FILE NUMBER: PLN22-006
SUBJECT: Building Site Approval, Design Review, Grading Approval, and Planning Clearance for a new single-family residence, ADU/JADU, livestock shelter, temporary agricultural employee housing, and associated improvements.
SITE LOCATION: Old Calaveras Road, (APN:029-35-007)

ADDITIONAL INFORMATION/ AREAS OF CONCERN

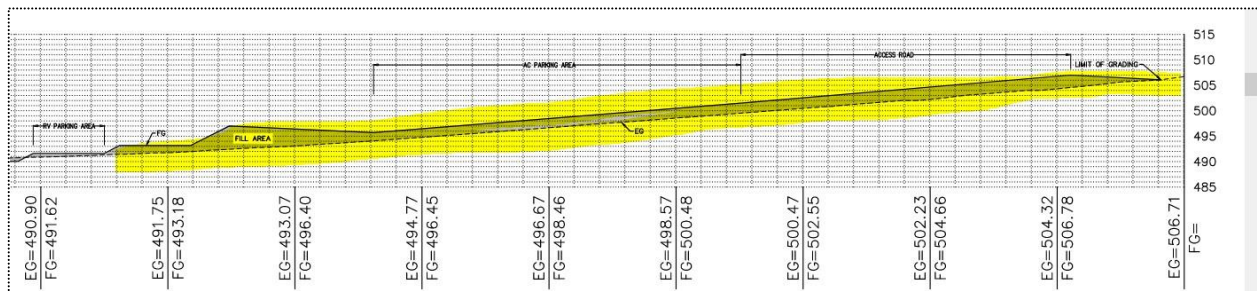
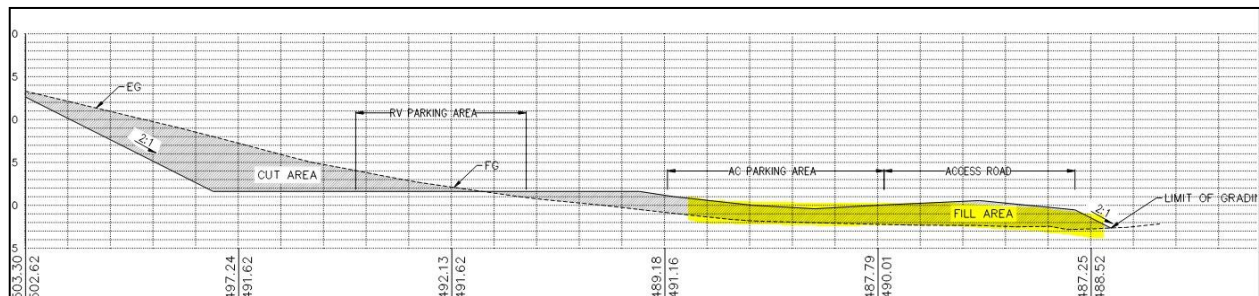
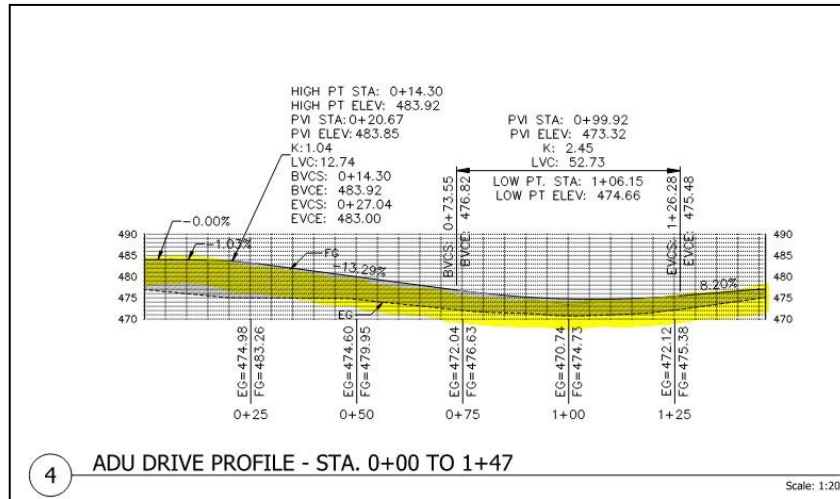
The proposed grading does not conform with these grading approval findings as there appears to be **excessive fill beneath the driveways** accessing the development site (refer to screen shots below). Please reduce the fill beneath the driveways so they are closest to grade as possible (refer to Guidelines for Grading and Hillside Development).

NOTE: If no members of the public are accessing the property, then the residential road width standard is a 15foot driveway width. If this is the case, please reduce the driveway width so it meets the minimum requirement. This is applicable for all driveways, including the driveway utilized on APN: 029-34-004. Please refer to comment #1 of the incomplete letter.

Response: The Livestock shelter is open to public and as noted by the county in the 'Preliminary Conditions of Approval' for 2/2/2024 hearing, LDE required the road to be 22' wide. We have also clarified this in our Additional info letter received as part of Incomplete Letter 2 in response to Comment 1 submitted on 4/20/2022.

The road width of 22ft is designed as per the guidance from LDE for the neighboring parcel Gokulam LLC (PLN-20-125) as part of incomplete letter1, Comment no. 26 saying that commercial agricultural uses need a road of width 22ft. Please find below the previous comment from LDE in **Green:**

26) Please demonstrate that the access road to the driveway shown on the plan conforms to County Standard Detail SD1 with a 22' width. Please include a driveway approach per SD4 that conforms to County standard slopes of less than 5% grade 20 feet from the edge of pavement or to the right of way, whichever is greater.

Please note that the overall grading quantity has slightly increased due to moving the Livestock shelter towards the south of the property based on discussions with the neighboring Golf Club and the county planner. In the hearing on 2/2, the zoning administrator urged us to work with the Golf club to address their concerns that the earlier location, though reducing the grading quantity, would have been constantly hit by golf balls being in the path of the nearby putting green. We subsequently met with them and then the county planner who requested us to submit our application with the changed location.

In addition, the Livestock shelter is open to public and thus needs an ADA parking spot that has less than 5% slope in all directions. The road to the north of the Livestock shelter has an uniform slope of around 8%. So, we updated the road height to the west of the new position of the Livestock Shelter so that the ADA parking provided here would be compliant.

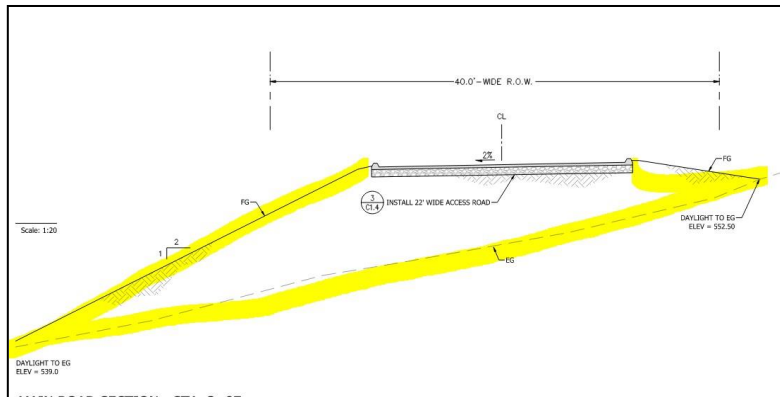
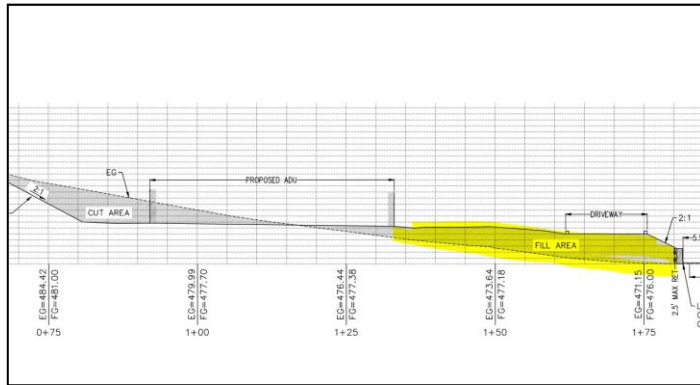
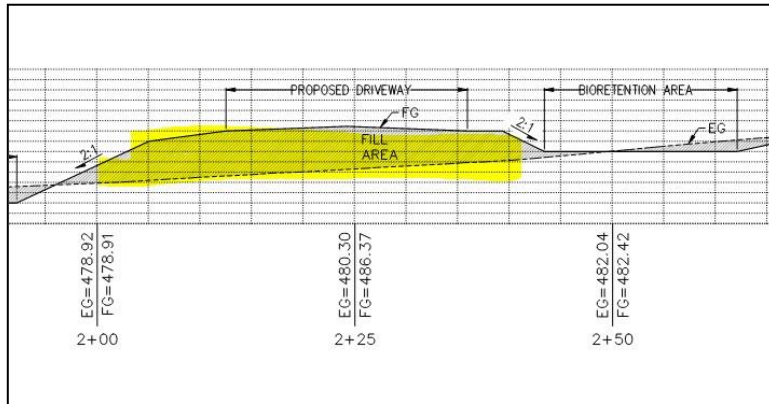
11. Fire department access is to be within 200 ft. exterior path of travel to all portions of a structure, this is currently being met. Fire department turnarounds are to be within 150 ft. exterior path of travel to all access area to reduce the amount of distance fire apparatus would need to reverse. Currently, a fire truck would need to reverse more than 150 ft. from the Main House to the turnaround. The distance between the structure and the turnaround would need to be reduced.

Property is located in the SRA and is also to meet PRC-4290. Per PRC-4290, all structures are to be within 50 ft. of a fire department turnaround.

Response: The fire truck turnaround location is changed and is within 50 ft to meet PRC-

Parking Areas

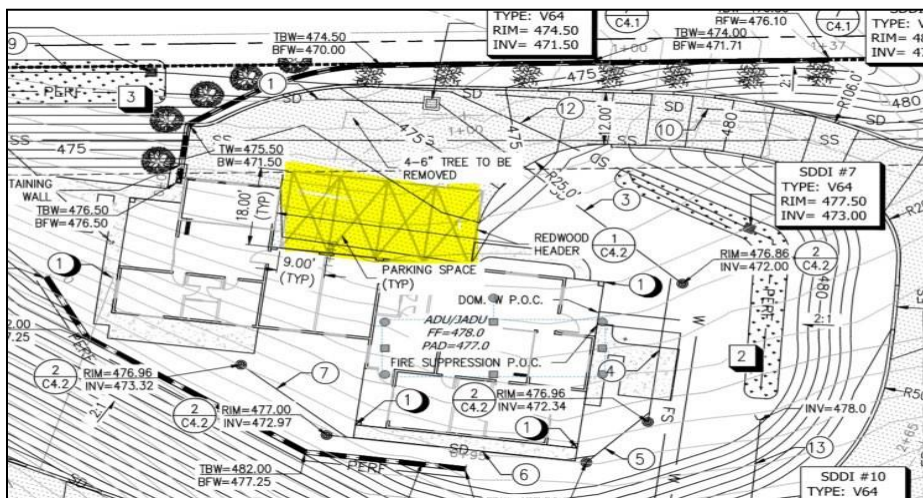
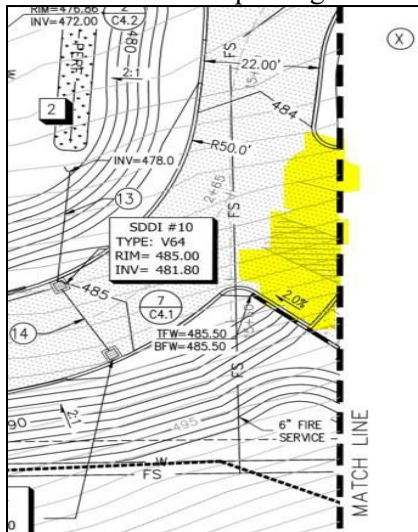
General Plan Policy R-GD22 notes that grading may be approved if it is determined to be the **minimum necessary** given the various site characteristics, constraints and potential environmental impacts that may be involved. The proposed single-family residence, ADU and JADU require a total of three parking spaces total. The proposal includes three garages (attached and detached) and three graded parking areas. This is in excess of what is the minimum necessary to establish the use on the property. Additionally, the creation of the parking areas (north of the ADU/JADU, west of the livestock shelter, and north of the Temporary Agriculture Residence area) results in excess cuts and fills that are not the minimum necessary for the use. Please revise the proposal to remove the parking areas and overall grading so it is in conformance with the General Plan. Refer to the below screenshots for the parking areas of concern.

Response: In response to your comment regarding the parking space near the ADU/JADU, we would like to clarify that we have created space to park two cars for the ADU and two cars for the JADU; two inside the garage and two outside away from the garage entrance. The rest of the driveway and road cannot be used as they are fire lanes and no parking is allowed. We have minimized the area here to what is needed to park and safely turn around.

Additionally, the clarification for the creation of the parking areas (north of the ADU/JADU, west of the livestock shelter, and north of the Temporary Agriculture Residence area) is as follows:

The parking on the west side of the livestock shelter is the only parking that has less than a 5% slope suitable for ADA parking, and one ADA parking spot is shown there. The road in this area had to be raised to reduce the slope to less than 5% to comply with ADA regulations for parking.
